BID MEMO 01

<u>Saints - Cafeteria & Viewing Area</u>

REVISION #01

New Orleans Saints Viewing Area and Cafeteria Expansion 5800 Airline Drive Metairie, Louisiana 70003

DRAWN BY I WDG A3.11

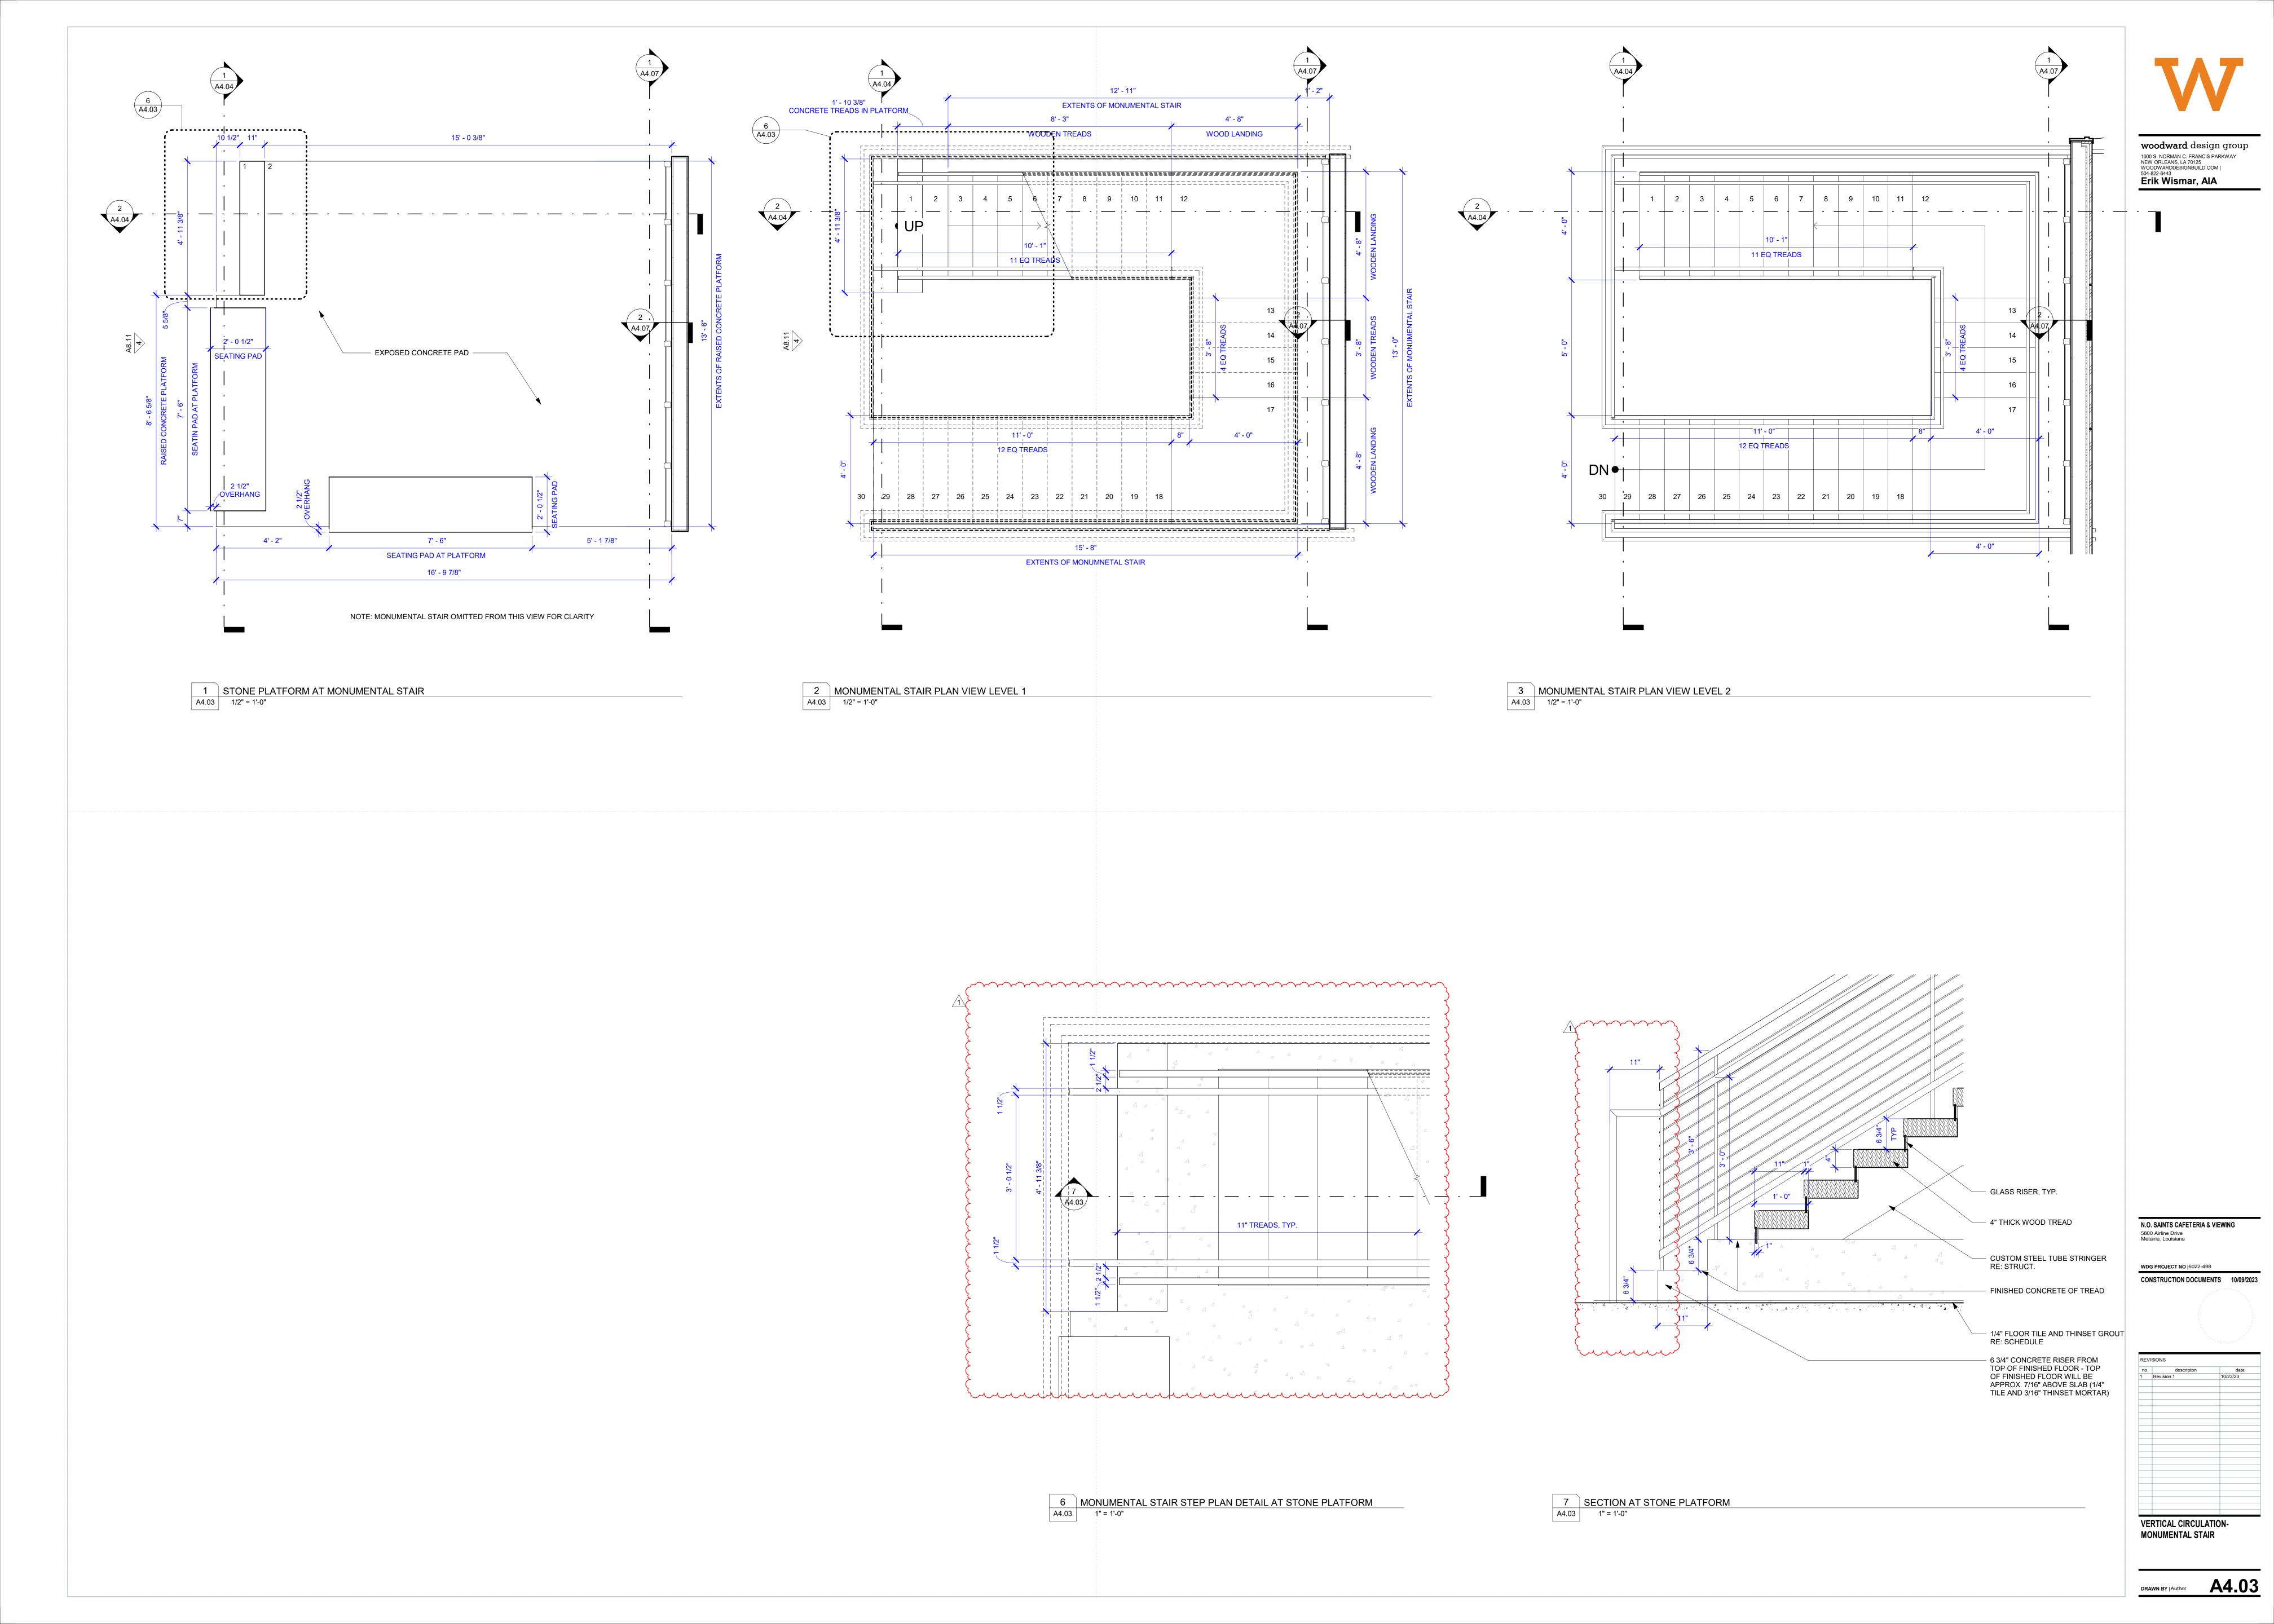
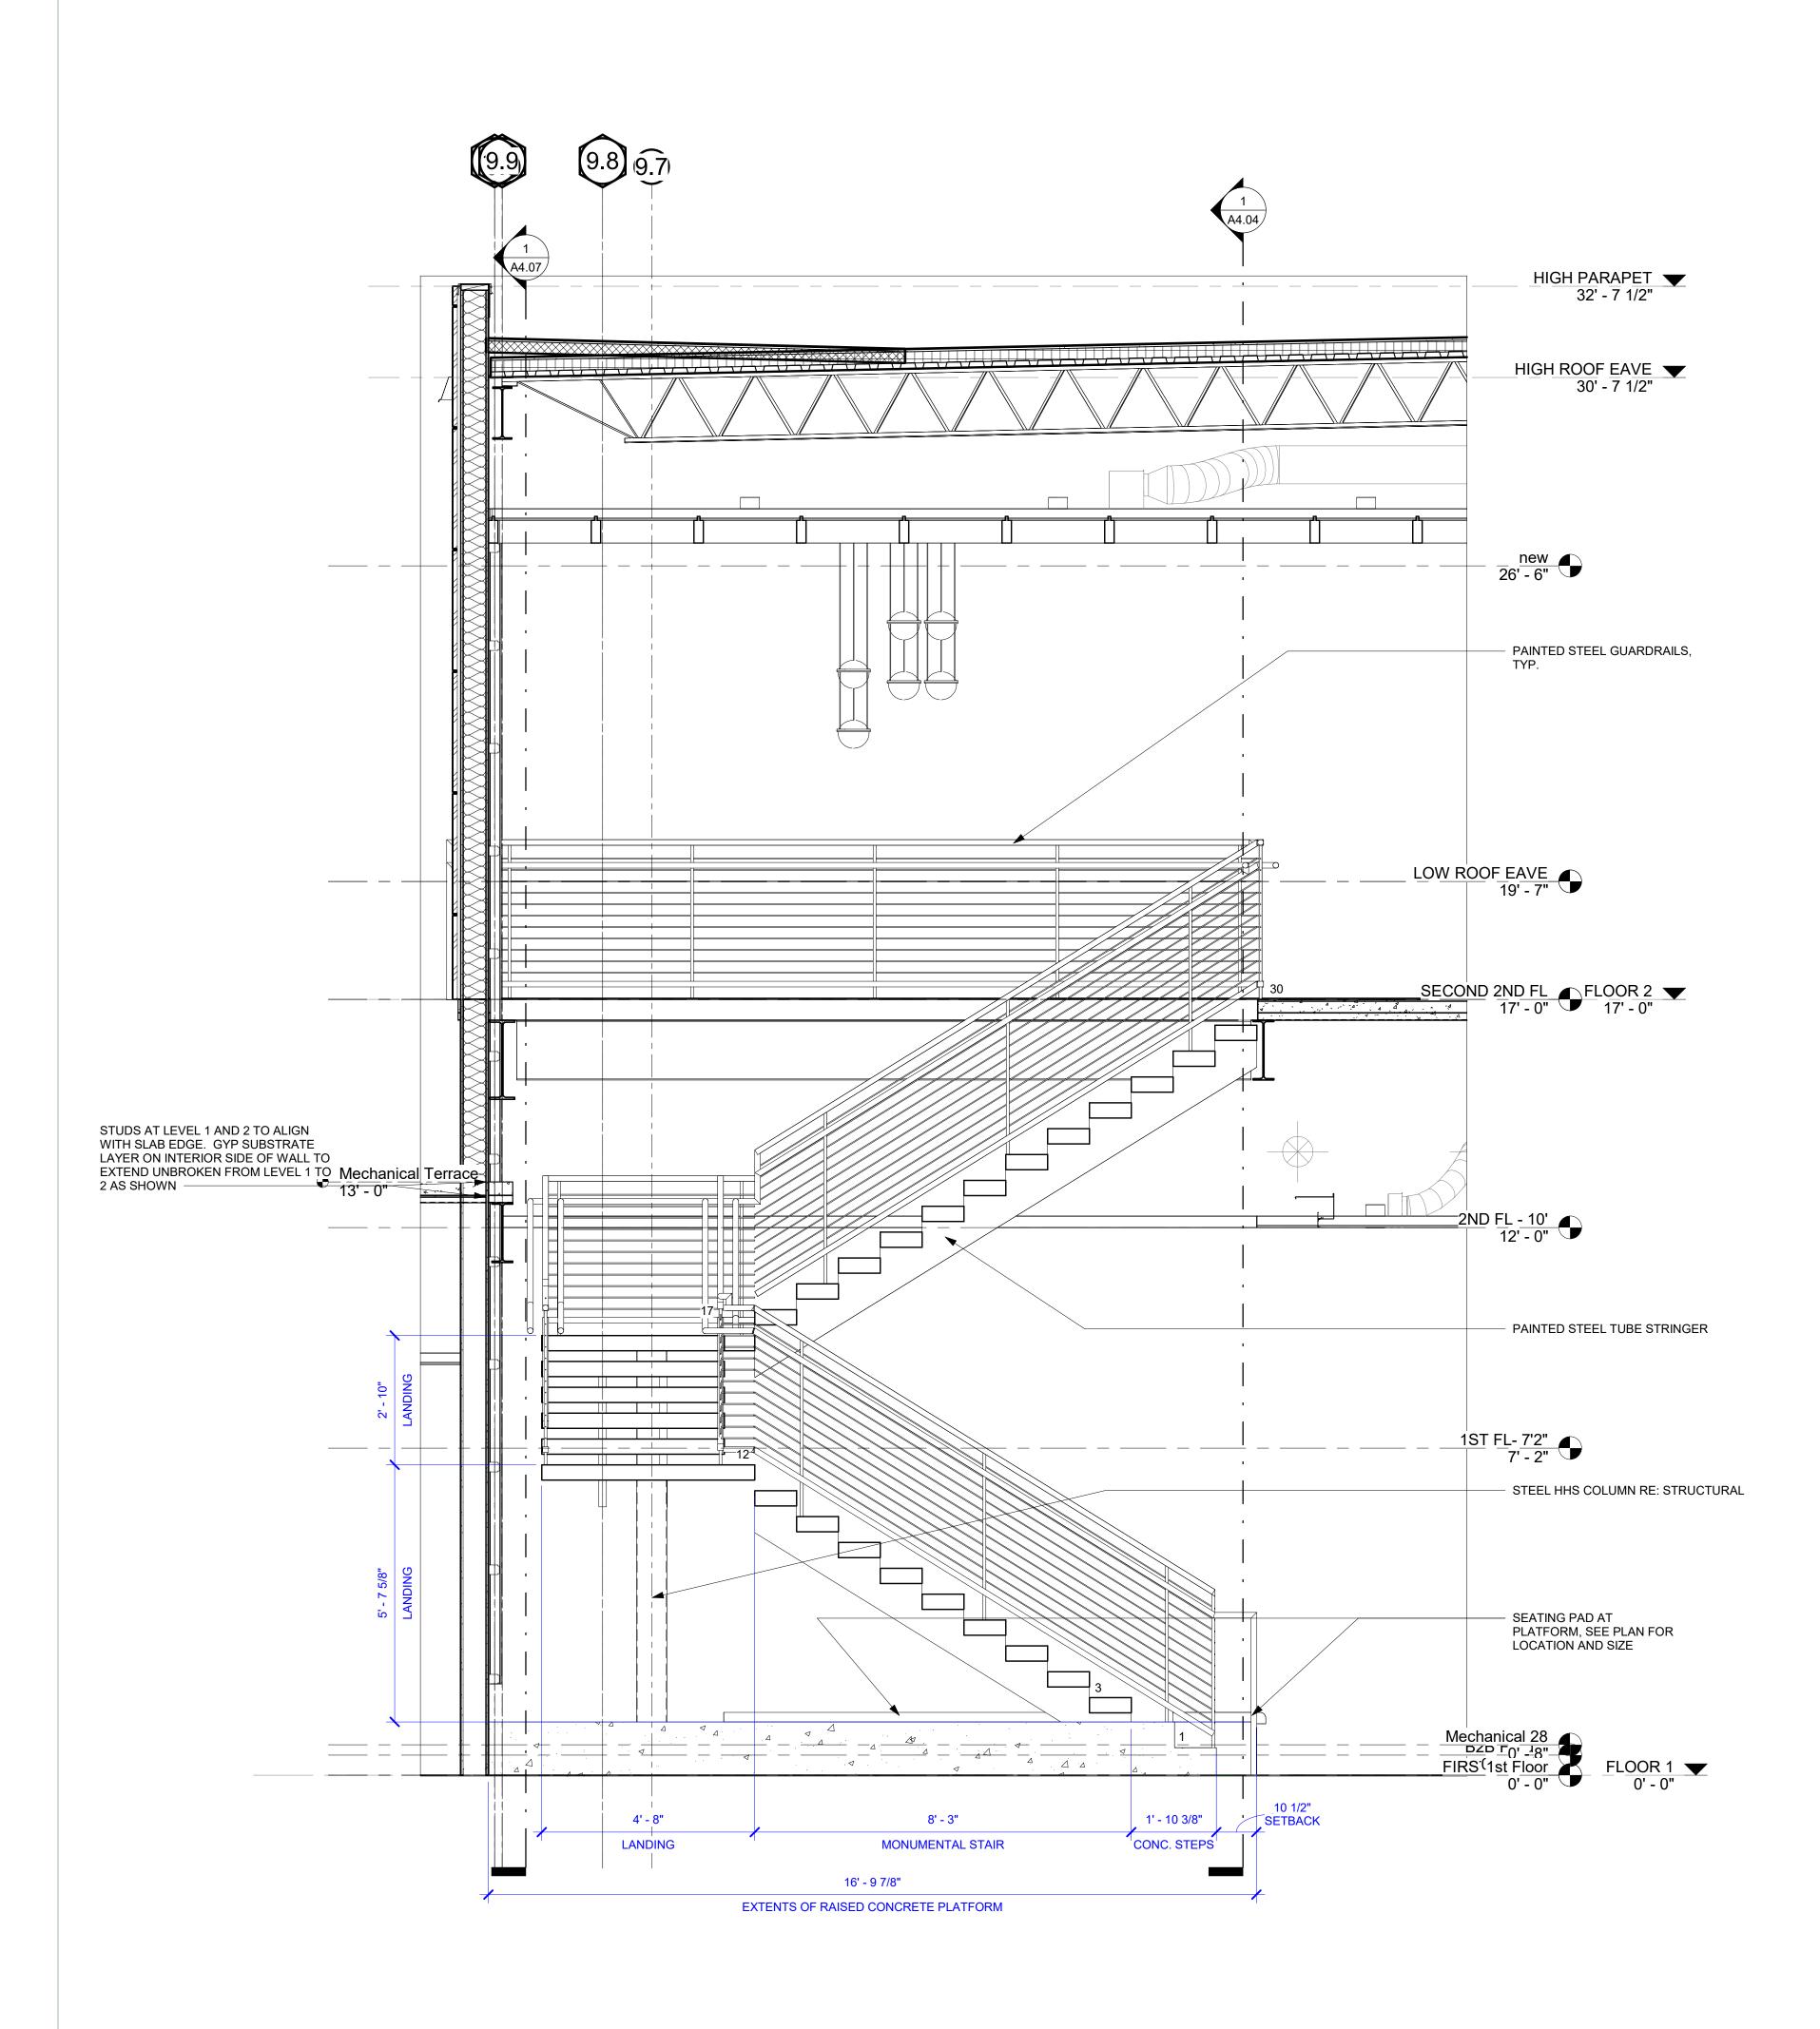
- 7'-0" tall louver screen detailed above restrooms with revised detail at valley gutter A3.11
- Revised monumental stair hand rail extension- A4.03
- Revised monumental stair section elevation A4.04

DRAWN BY | Author A4.06

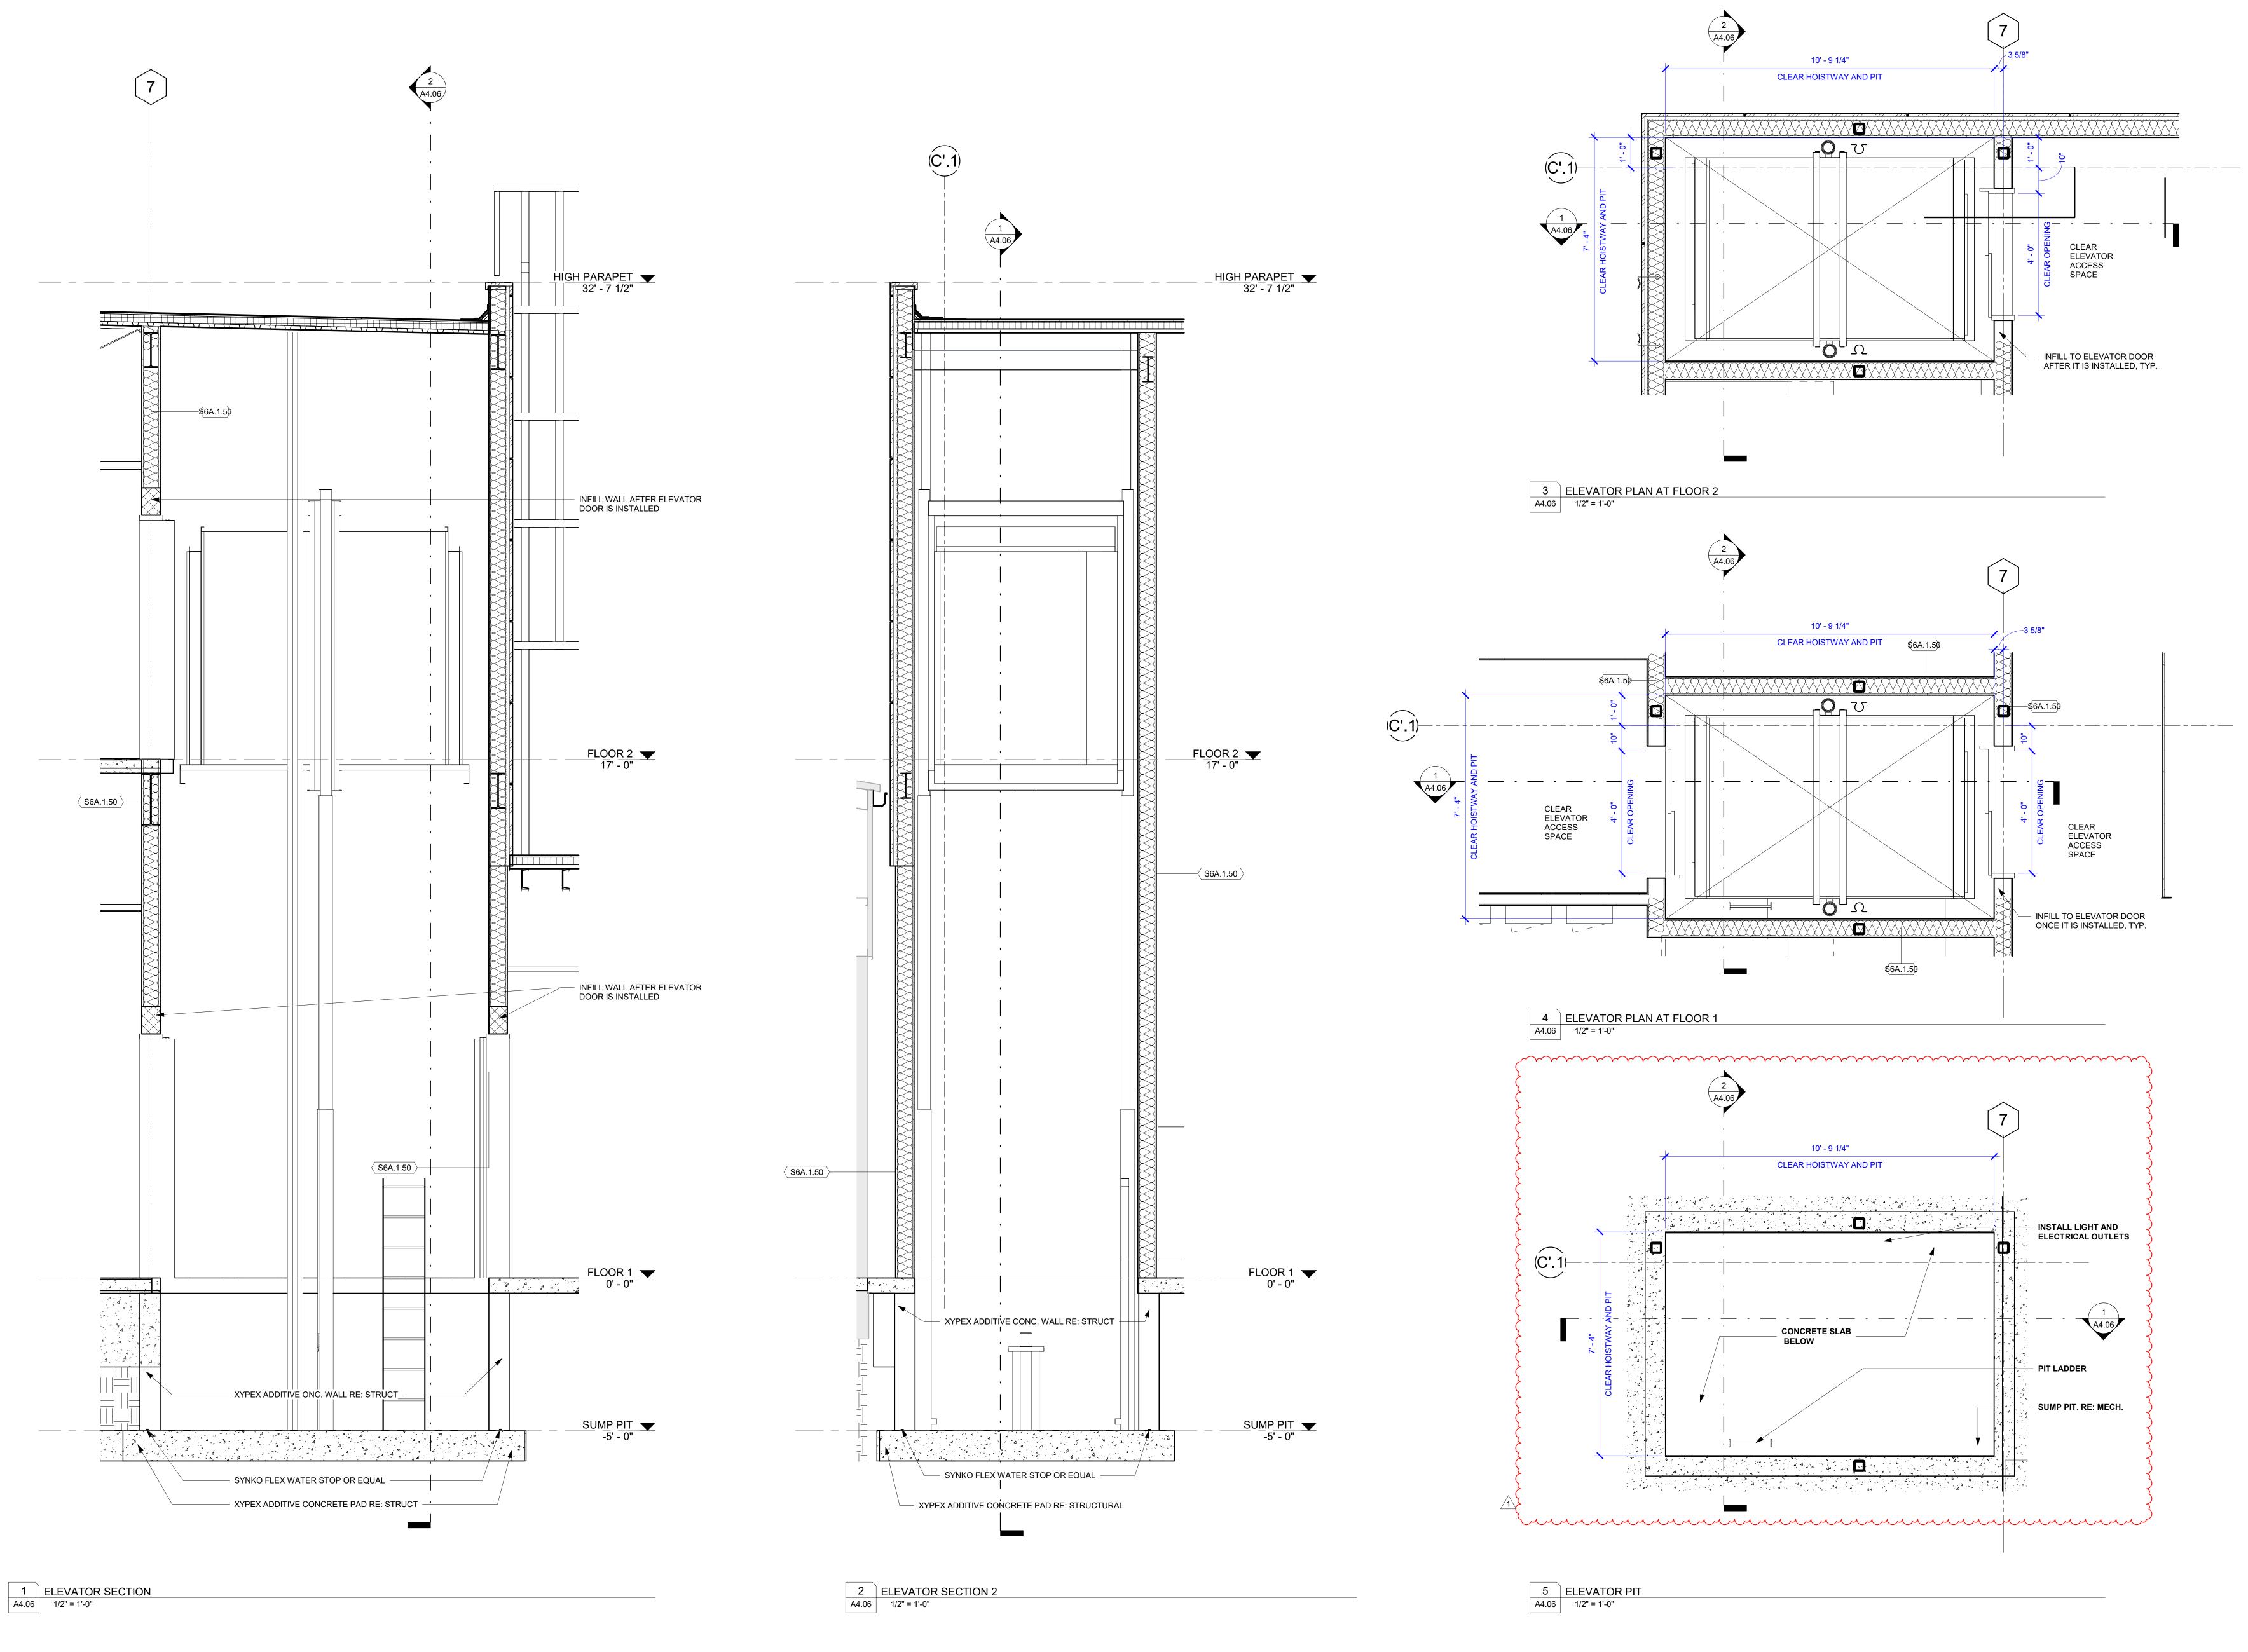
- Graphics fixed at elevator pit- A4.06
- Revised feature wall details at monumental stair A4.07
- Parapet roof details revised showing louver and post over structural beam condition A5.10
